**LEWIS AND CLARK COUNTY  
Murray Building Generator Replacement  
ELECTRICAL ADDENDUM #1  
February 21, 2025**

# 1200 Amp MDP

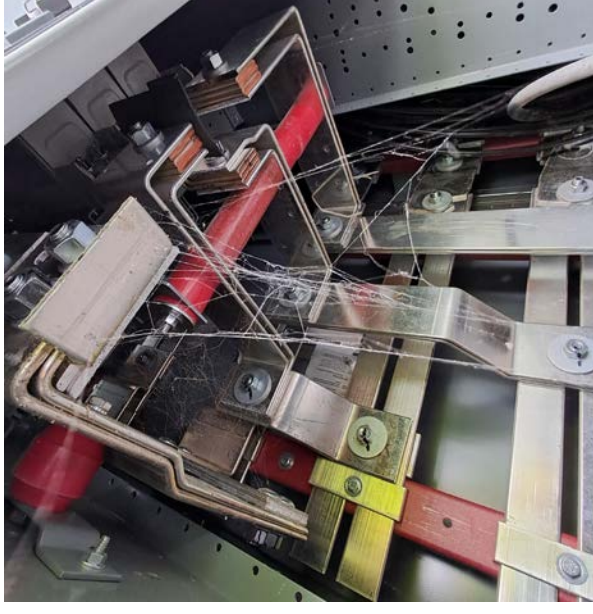
- 1) Discussion during the pre-bid meeting regarding the method for connecting the new ATS to the existing MDP ended with the decision that new lugs would need to be added to the existing MDP on the load side of the 1200A main breaker. The bidder shall include this load side connection method in their bid.
- 2) Due to the connection point indicated in #1 above, the new ATS shall be changed to non-service rated.
- 3) The photo titled "Box between main panel and the generator" appears to indicate that the feeders from the existing MDP to existing panel EP can remain routed through this box and be connected directly into panel EP instead of through the existing ATS. This junction box shall remain, but any existing generator/ATS connections shall be removed.
